PRODUCT/PROCESS CHANGE NOTICE (PCN)

PCN #: A1301-08 Product Affected: 3.0mm x 3.0mm VFQFPN-20 4.0mm x 4.0mm VFQFPN-24 4.0mm x 4.0mm VFQFPN-28 (Refer to Attachment 2) Date Effective: May 5, 2013	DATE: February 5, 2013	MEANS OF DISTINGUISHING CHANGED DEVICES: <input type="checkbox"/> Product Mark <input type="checkbox"/> Back Mark <input type="checkbox"/> Date Code <input checked="" type="checkbox"/> Other <div style="margin-left: 100px;"> Assembly lot marked on the device provides traceability to the material used </div>
---	--------------------------------------	--

ATTACHMENT 1 - PCN # : A1301-08

PCN Type: Assembly Process and Material Change

Figure 1: Illustration of Interposer Inserted between top die and bottom die (Top View)

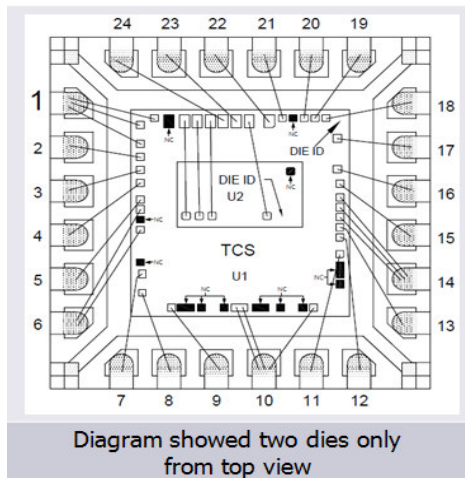
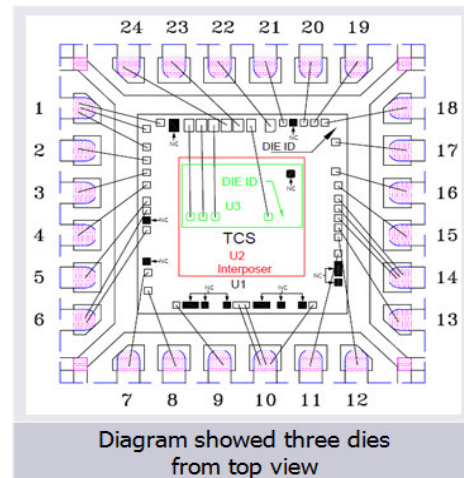
This notification is to advise our customers that IDT has successfully completed the qualification of stack die assembly with interposer. An interposer will be added in between the top die and the bottom die to improve assembly yield.

The die attach material for the top die will change to NEX-130SB-25 and for the bottom die to 8200T.

Figure 2: Illustration of Interposer Inserted between top die and bottom die (Side View)

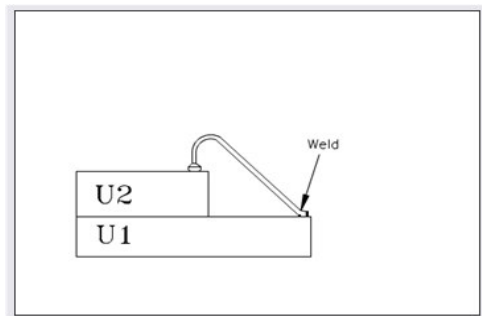
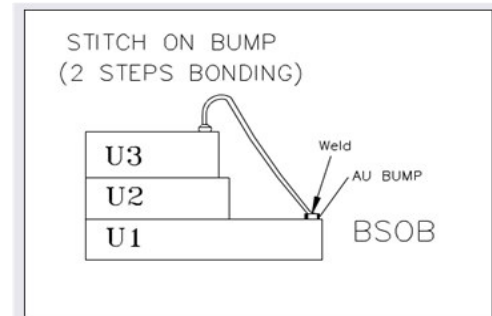
Diagram showed two stack dies only from side view

Diagram showed three stack dies from side view
